# Spartan Motors Chassis, Inc.

## SERVICE BULLETIN

RSB13-810-001

**SUBJECT:** Spartan Motors Chassis, Inc. has determined a defect relating to Spartan APS supplied by Takata Protection Systems, Inc. may exist in certain emergency response chassis.

**FIG. 3-1**

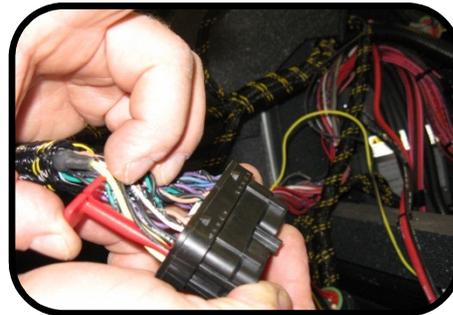
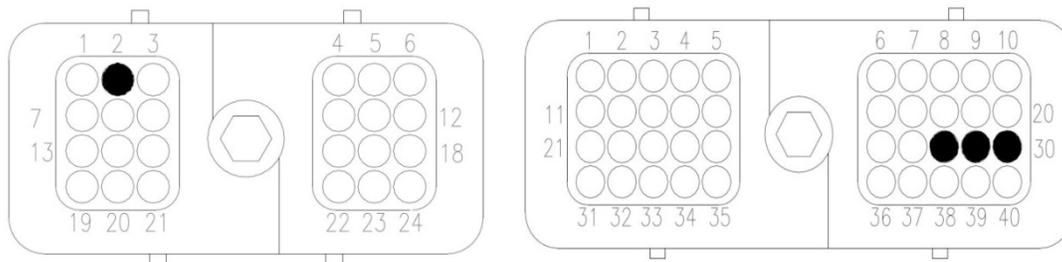
7. In the 24-way RCM interface connector using the supplied de-pinning tool (0411-240-2005), de-pin and remove wire SP1599B from cavity 2. Refer to FIG. 3-1.
8. In the 40-way RCM interface connector using the supplied de-pinning tool (0411-240-2005), de-pin and remove wires SP1599C from cavity 28; SP1599D from cavity 29; SP1599E from cavity 30. Refer to FIG 3-1.

**FIG. 4-1**

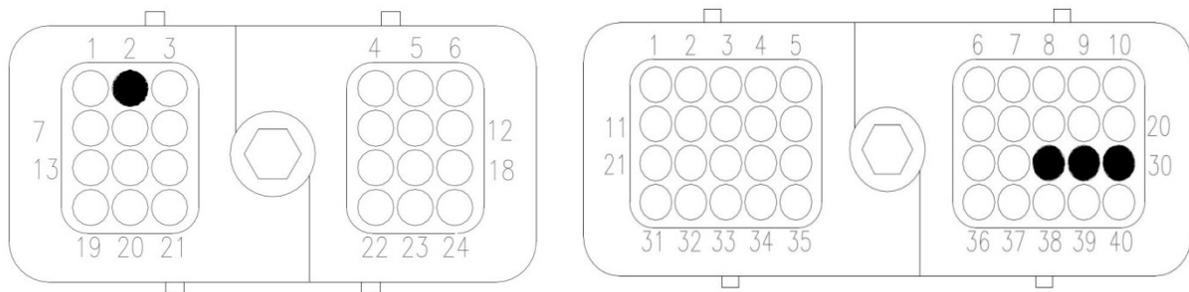
11. In 24-way interface connector pin ground wire from the RCM ground harness (supplied) into cavity 2. Refer to FIG. 4-1.
12. In 40-way interface connector pin ground wires from the RCM ground harness (supplied) into cavities 28, 29, and 30. Refer to FIG. 4-1.

**FIG. 6-1**

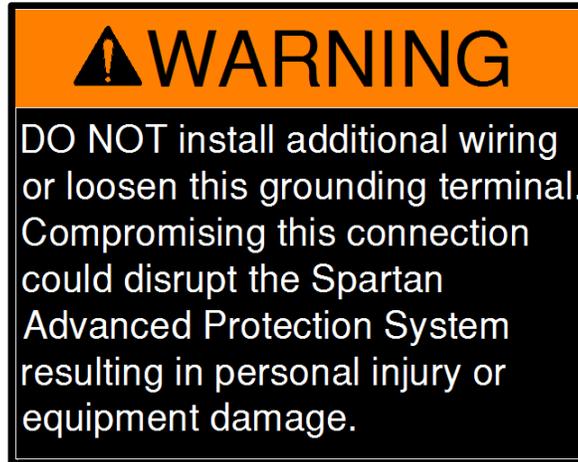
18. Add warning label (3893-NN-012) to the front bulkhead inside of the cab next to the mounting screw. Refer to FIG. 6-1.

**FIG. 7-1**

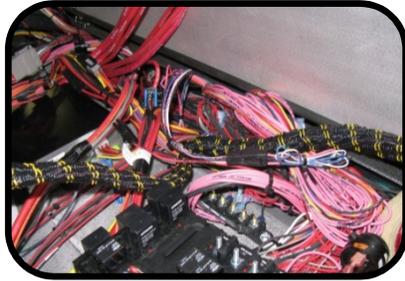
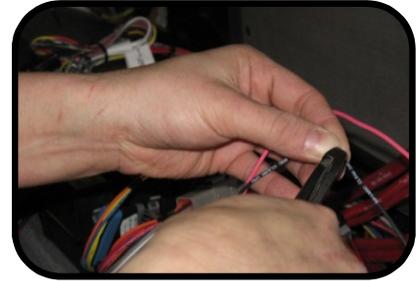
20. Locate SP185 wire connected to SP1599, behind the rocker switch panel, center forward location, cut off the connector and terminal, loop and heat shrink the wire. Refer to FIG. 7-1.

**FIG. 7-2**

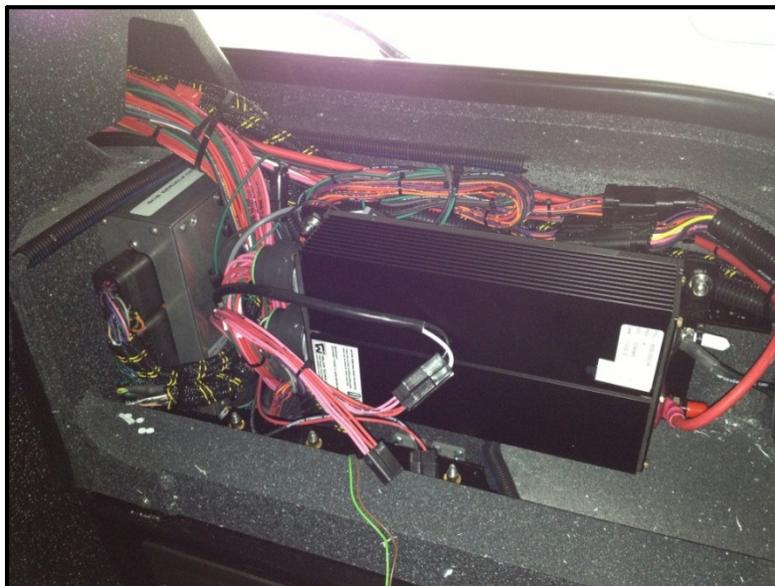
21. Connect supplied RCM to connectors as shown in the document below and torque the connections as shown with a 4mm Allen wrench. Torque 27 lbs. in. Connect the round connector located on bottom of the RCM. Be sure to install tamper evident sticker over the connection point.
22. Once RCM is installed, excess/service loop of harnesses must be zip tied back in place so remaining component(s) may be installed. Once this has occurred re-install the electrical device(s) in its mounting position. Refer to FIG. 7-2.
